STAFF REPORT
(Final Plat, Preliminary Plat Approved 2/3/00)

CASE NUMBER: S/D 00-07-- ZOO BUSINESS PARK

VICINITY MAP

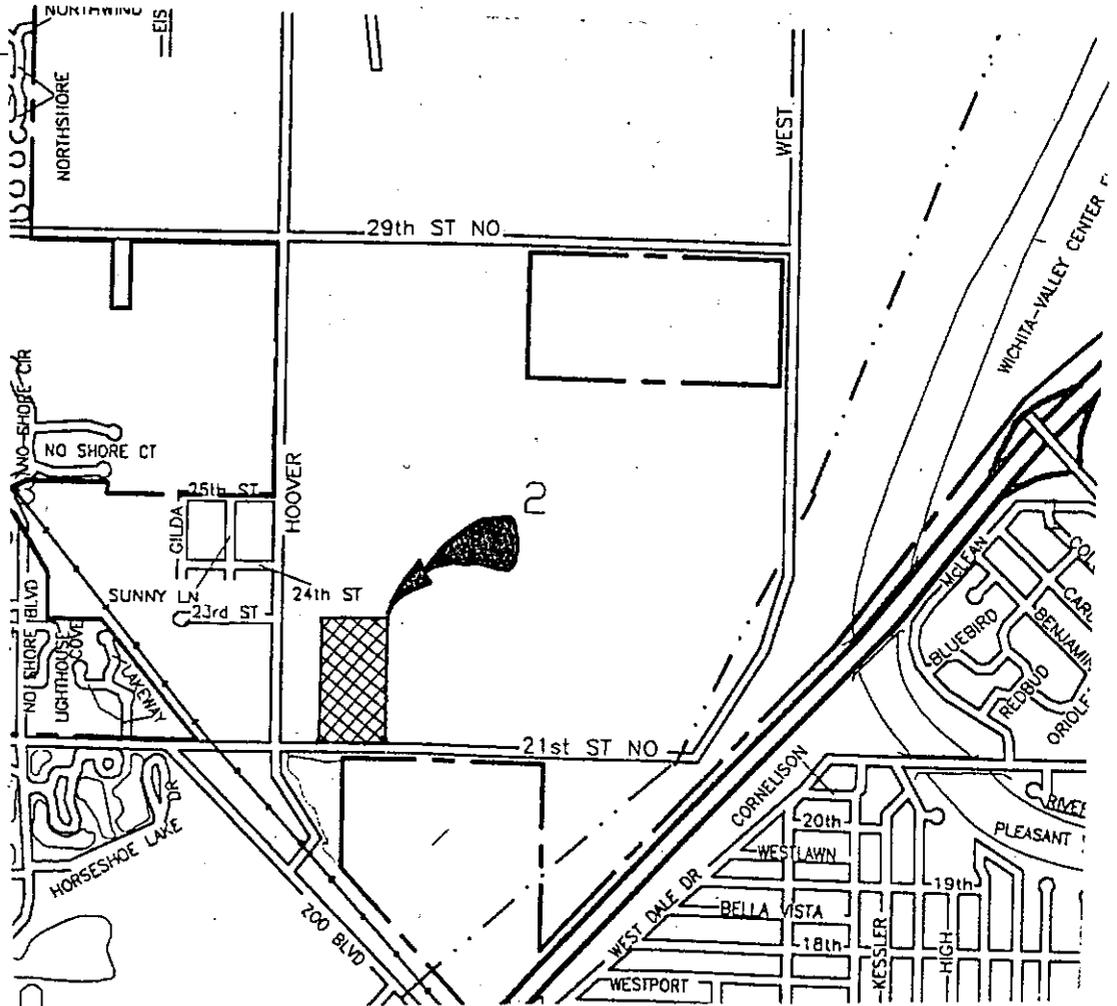
- A. The applicant shall submit a guarantee for extension of City water and sanitary sewer. **A sanitary sewer layout is requested.**
- B. Depending upon the status of City water and sanitary sewer, the **Health Department** needs to comment on the possible use of on-site temporary facilities for this site. **The applicant has requested a temporary holding tank for a portion of the site for use until municipal sewer is available.**

- D. **City Engineering** needs to comment on the status of the applicant's drainage plan.
- E. **County Engineering** needs to comment on the need for access controls. **The Subdivision Committee approved one opening along 21st Street.**

- F. **County Engineering** needs to comment on the need for additional right-of-way. **County Engineering has requested the dedication of an additional 10 foot of right-of-way for 21st Street North.**

- K. The recording data on the pipeline easement needs changed from "Book" to "Film".
- L. The pipeline company needs to approve the portion of Zoo Park Circle located over the pipeline easement and located within the pipeline setback.

- M. The west boundary of this plat may need to be revised due to monuments set by Baughman Company for the proposed plat to the west.

- P. City Fire Department should comment on the length of the internal street, which is approximately 1,300 feet, exceeding the 600-ft limitation required by the Subdivision Regulations. City Fire Department has requested an emergency access easement across Lot 10 connecting with 21st Street North to provide an additional point of access.

- R. In order to facilitate development of the adjoining property to the west and reduce the number of access openings along Hoover Road, MAPD requests that the internal street be extended to the west property line at two locations – between Lots 4 and 5 and at the south line of Lot 1.

The requested right-of-way has been dedicated on the final plat.

- The requested emergency access easement has been platted.
- Q. City Fire Department should comment on the plat's street name. The street name shall be Zoo Park Circle.
